DEVIATION REQUEST AND DECISION FORM

Project Name : CLOVERLEAF FILING NO. 2
Schedule No.(s) : 7124202236, 7124202239, 7123103007, 7124202238
Legal Description : SEE ATTACHED -- Exhibit B

A deviation from the standards of or in Section **ECM Ssection 3.3.1.J.2** of the Engineering Criteria Manual (ECM) is requested.

DP05 PROFILE
STA 1+00.00 TO 10+31.15

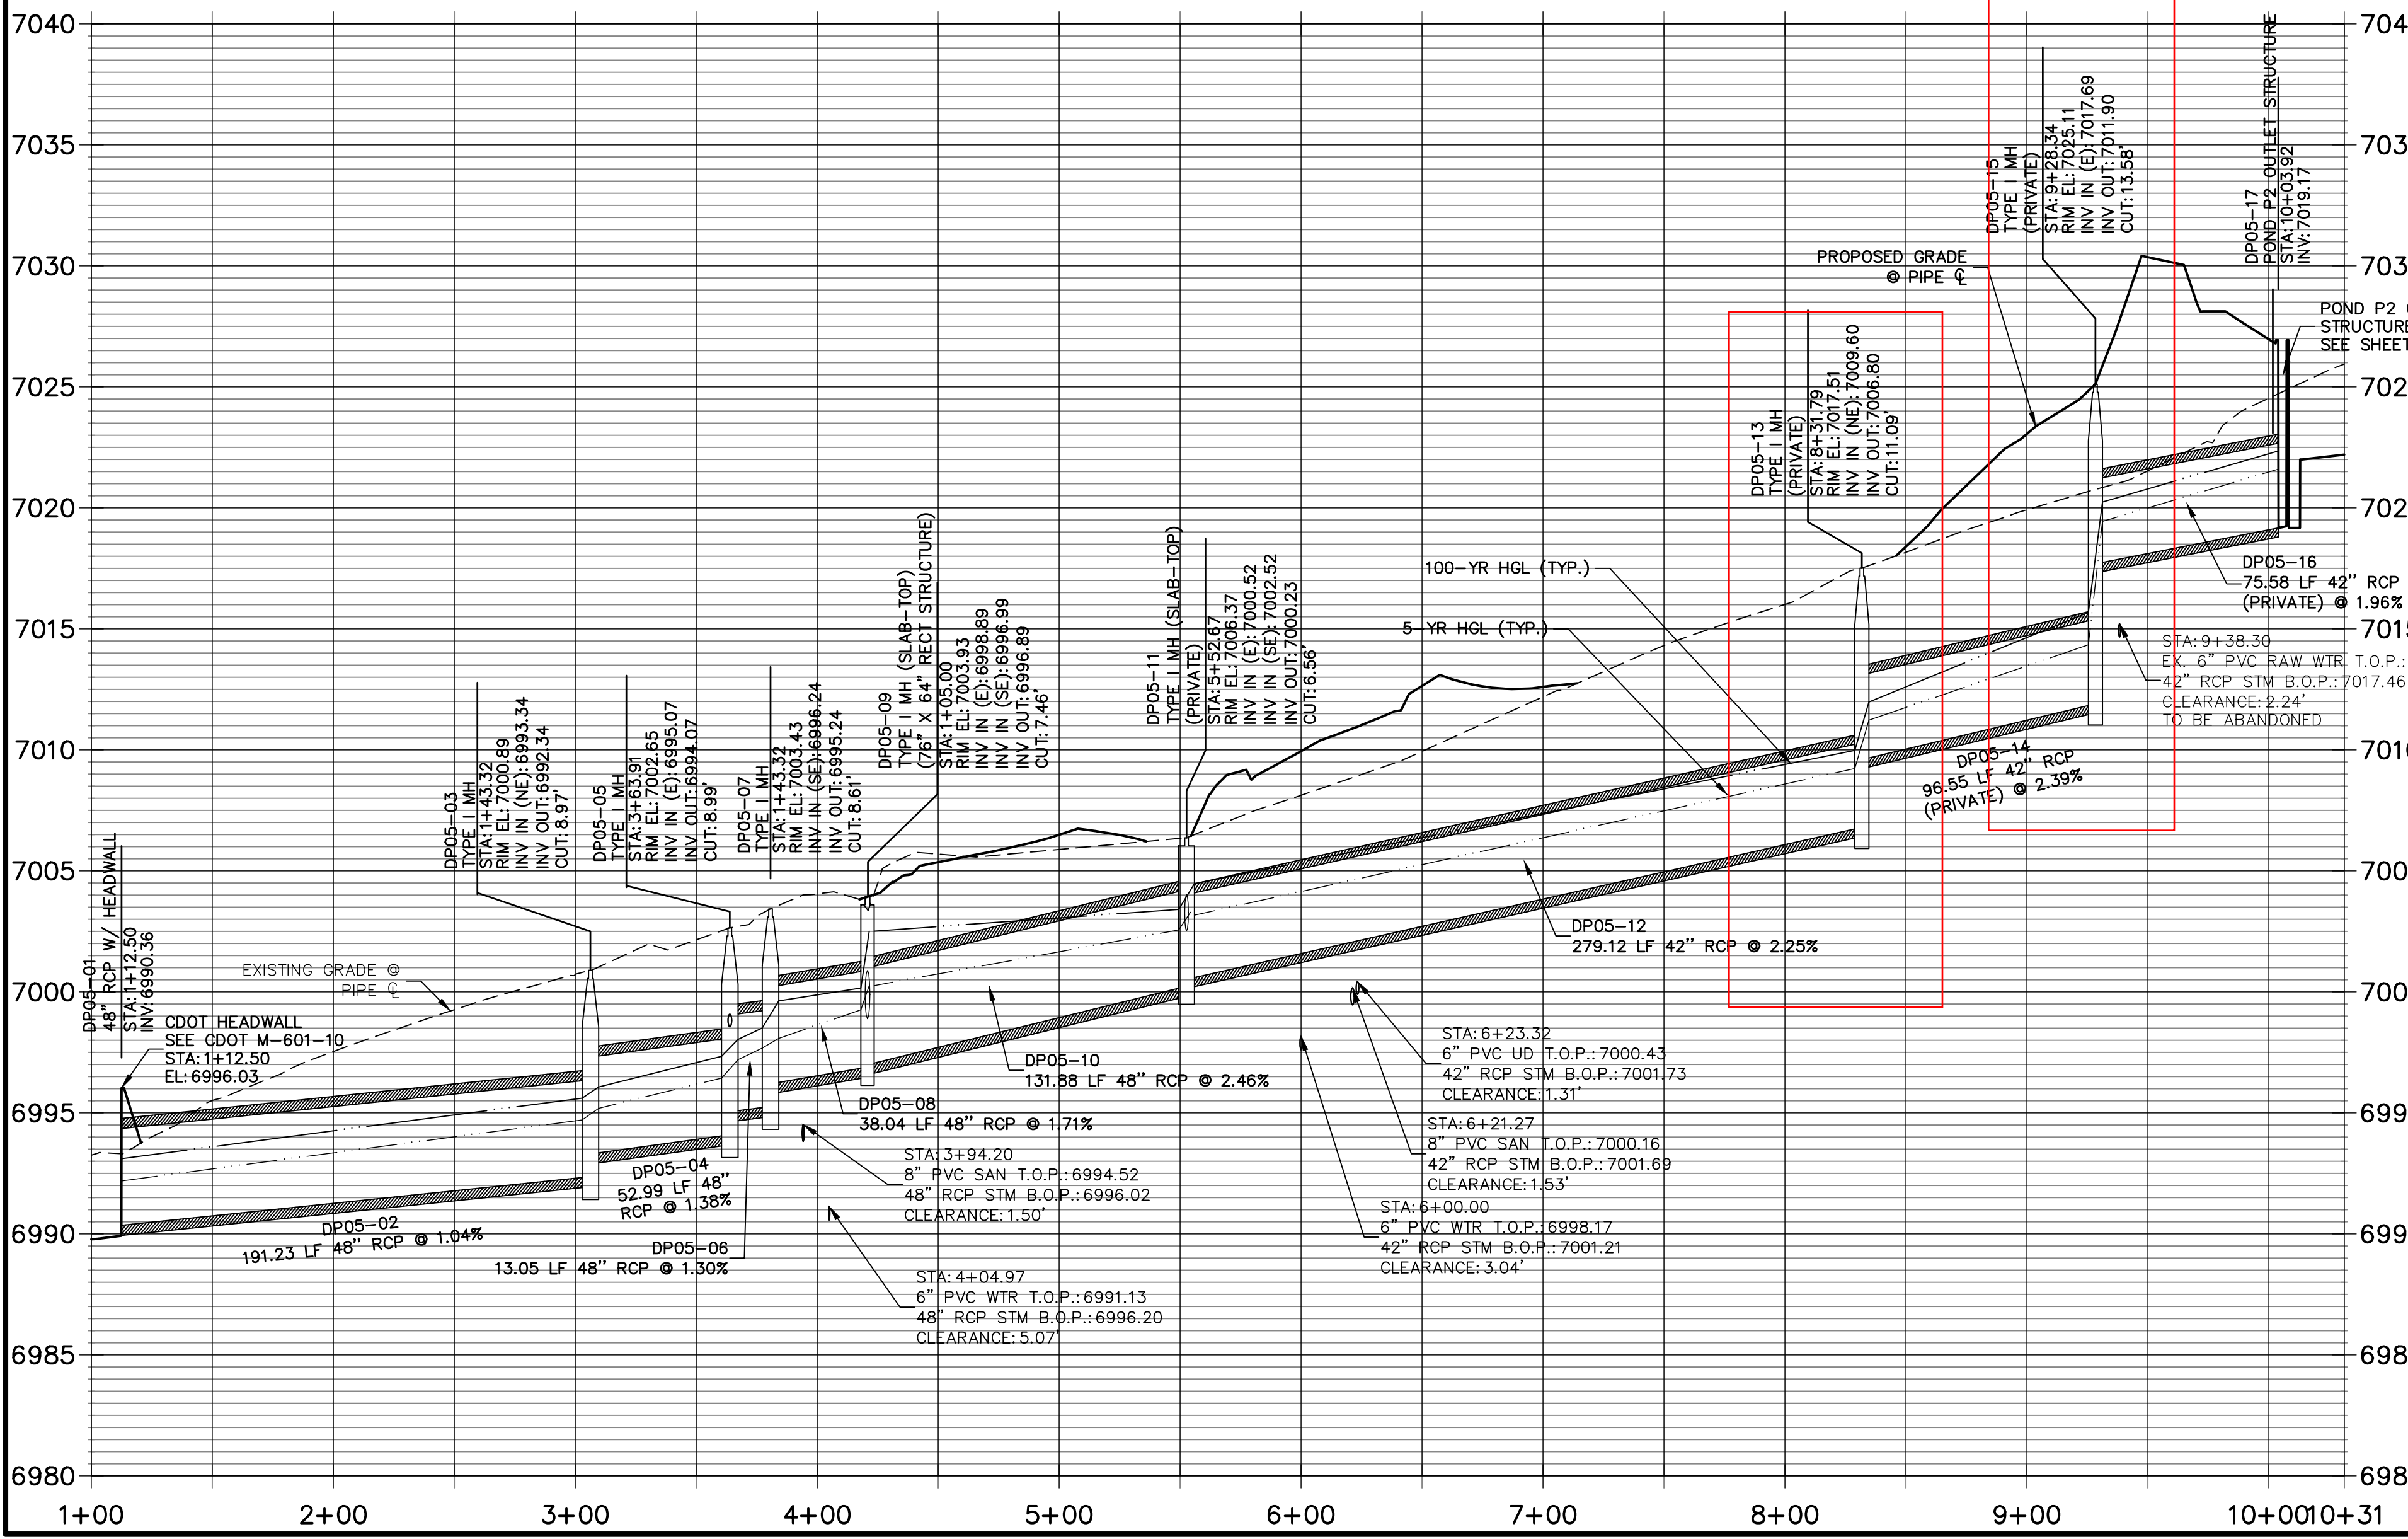
MH-DP05-15 (5.8 ft. drop) and MH-DP05-13 (2.8 ft. drop): Pond 2 outfall to Bowstring. Slopes and associated velocities within the storm sewer system are optimized to be just below the allowable maximum velocity for the Q100 event.

This request has been determined to have met the criteria for approval. A deviation from Section 3.3.1.J.2 of the ECM is hereby granted based on the justification provided.
